UNITED STATES PATENT AND TRADEMARK OFFICE

APPLICATION NO.	FILING DATE	FIRST NAMED INVENTOR	ATTORNEY DOCKET NO.	CONFIRMATION NO.
10/603,250	06/25/2003	John T. Ulman	PPC-5006	3681

Office Action Summary	Application No.	Applicant(s)	
	10/603,250	ULMAN, JOHN T.	
	Examiner	Art Unit	
	Michael G. Bogart	3761

DETAILED ACTION

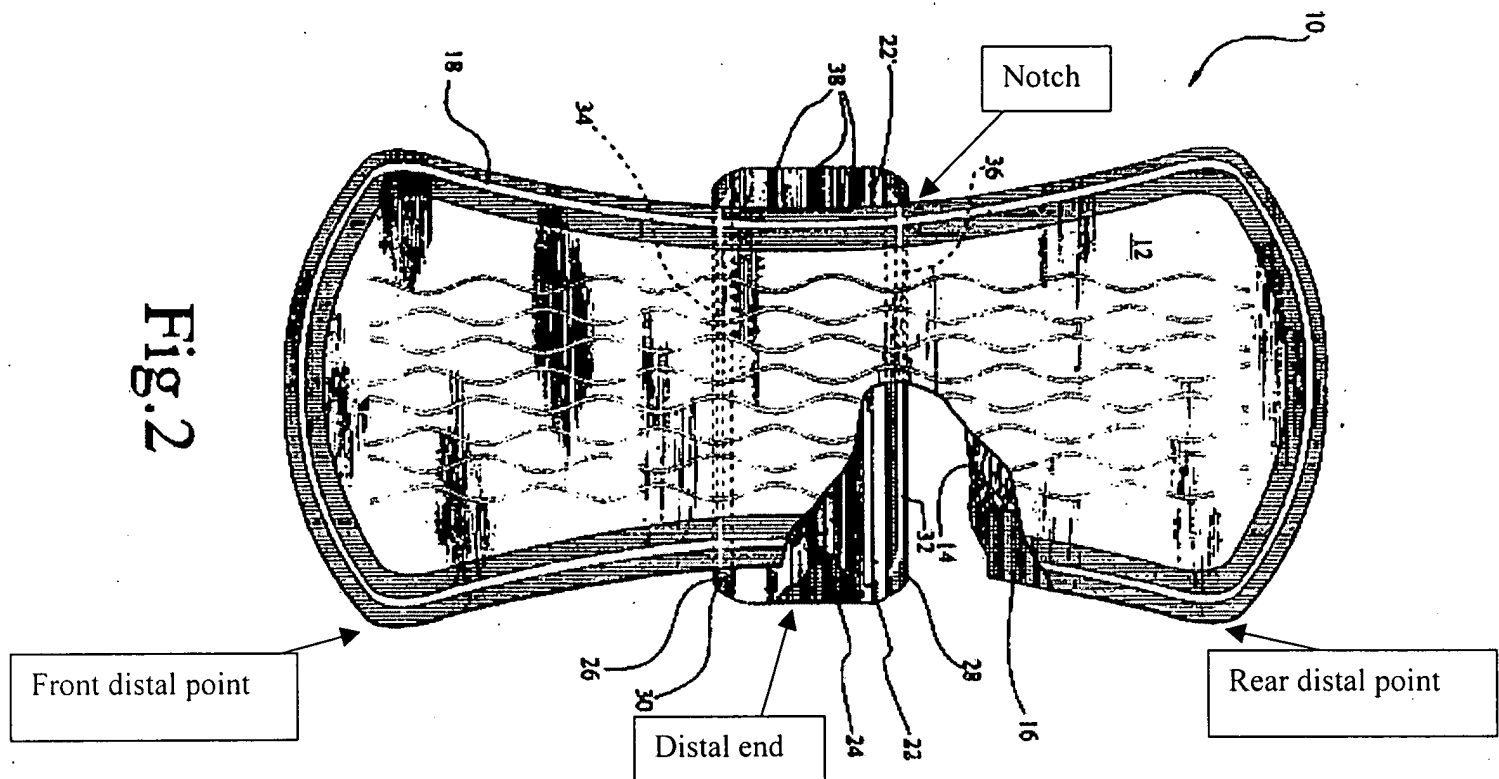
Regarding claim 1, Brisebois teaches a sanitary napkin (10) comprising:

a main body (12, 14, 16), the main body (12, 14, 16) comprising a fluid-permeable cover layer (12), a liquid-impervious barrier layer (16) and an absorbent system (14) intermediate the

cover layer (12) and the barrier layer (16), wherein the main body (12, 14, 16) comprises a front portion, a rear portion and a center portion intermediate the front portion and the rear portion, and wherein the front portion extends laterally to at least one outermost front distal point and the rear portion extends laterally outward to at least one outermost rear distal point; and

a side flap (22) projecting laterally outward from the absorbent system (14), extending laterally outward from a proximal edge (18) of the center portion and adapted to be folded over a crotch portion of a user's undergarment in use, the side flap (22) extending laterally outward from the proximal edge (18) to a distal end, wherein the distal end is not substantially laterally outward from the at least one outermost front distal point and the distal end is not substantially laterally outward from the at least one outermost rear distal point, and wherein the at least one outermost front distal point, the at least one outermost rear distal point, and the side flap (22) are each positioned on a single side of a longitudinally extending center line of the sanitary napkin (10)(col. 5, line 63-col. 6, line 33)(see figure 2, below).

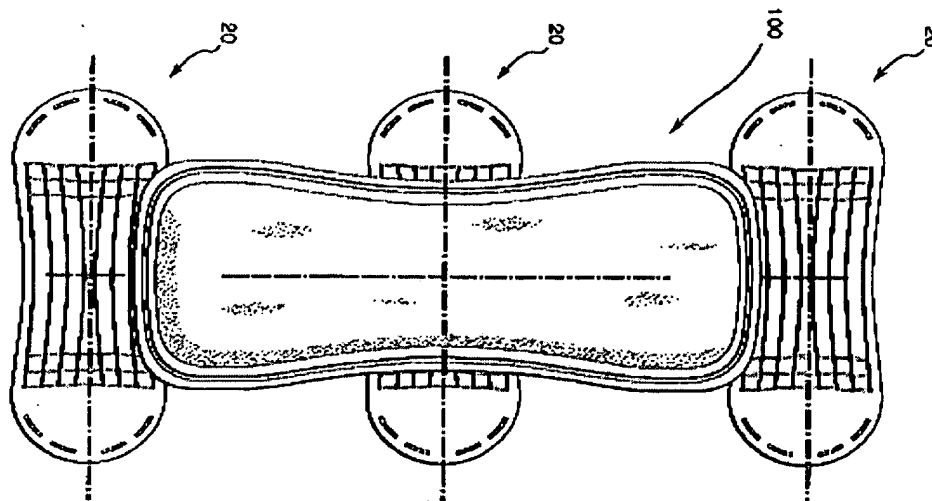
Claims 1 and 12 are rejected under 35 U.S.C. § 102(e) as being anticipated by Brisebois (US 2002/0143311 A1)(hereinafter: '311).

Regarding claim 1, '311 teaches a sanitary napkin (20) comprising:

a main body (22), the main body (22) comprising a fluid-permeable cover layer, a liquid-impervious barrier layer (41) and an absorbent system (40) intermediate the cover layer and the barrier layer (41), wherein the main body (22) comprises a front portion, a rear portion and a center portion intermediate the front portion and the rear portion, and wherein the front portion extends laterally to at least one outermost front distal point and the rear portion extends laterally outward to at least one outermost rear distal point; and

a side flap (20) projecting laterally outward from the absorbent system (40), extending laterally outward from a proximal edge (24, 26) of the center portion and adapted to be folded over a crotch portion of a user's undergarment in use, the side flap (20) extending laterally outward from the proximal edge (24, 26) to a distal end, wherein the distal end is not substantially laterally outward from the at least one outermost front distal point and the distal end is not substantially laterally outward from the at least one outermost rear distal point, and wherein the at least one outermost front distal point, the at least one outermost rear distal point, and the side flap (20) are each positioned on a single side of a longitudinally extending center line of the sanitary napkin (20)(see figure 6, below).
